## SFCTA Board meeting Item 8 PAX initiation report

**SFCTA July 12 item 8 PAX Initiation report.pdf**  
868K

PAX 42-foot OD (Figure 7-14)

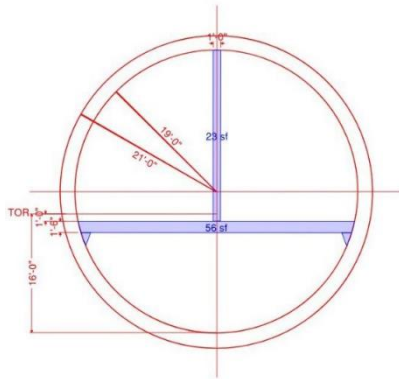
- The report includes two 42-foot Outer Diameter (OD) single bore alternatives (A1 and B1) allegedly cost-competitive with equivalent twin-bore solutions (B1 and B2). **This 42-foot diameter does not appear to be sufficient to accommodate the two walkways (one on each side of the dividing wall) required for the safe evacuation of mobility-impaired passengers in an emergency.** As an example, the Groene Hart tunnel has an outer diameter of 14.9m (49 feet), including the two walkways.

February 2012 satellite picture showing the two TBMs (including trailing gear) being assembled in the staging area. The first TBM was transported by SPMT to the portal and launched two months later (April 2012).

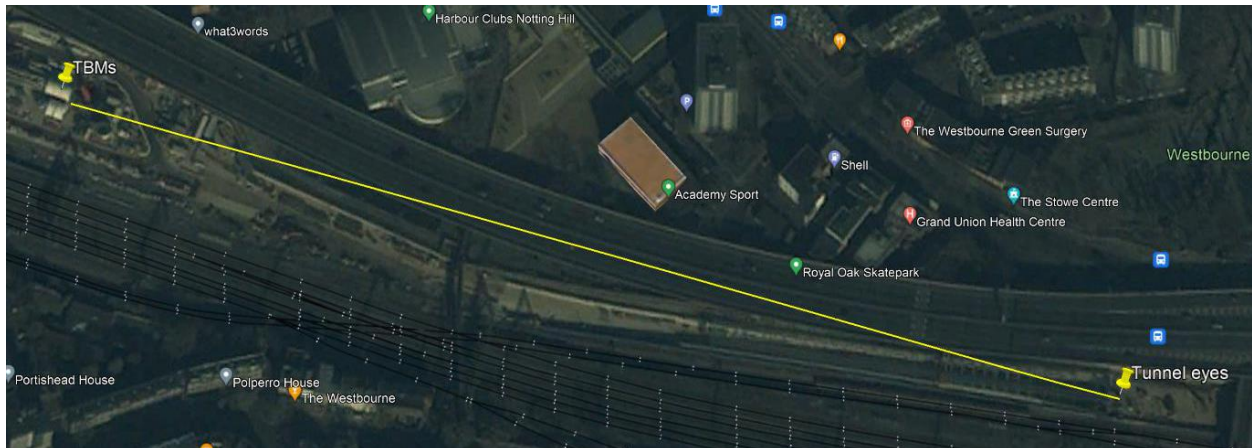
Alternative B3 is modelled after Crossrail's Royal Oak Portal which had constraints similar to the 23<sup>rd</sup> St location (69-foot-wide worksite tucked under a freeway overpass) leaving no room for staging which was located on a worksite approximately 1,600 feet east of the portal (the staging area north of Cesar Chavez is approximately 1,000 feet from the 23<sup>rd</sup> St portal).

The second TBM was transported to the portal and launched in June 2012 (after the first TBM and its trailing gear were fully buried) because the ramp leading to the portal was too narrow to accommodate more than one TBM at a time (<https://youtu.be/77x3q6k27k4>)
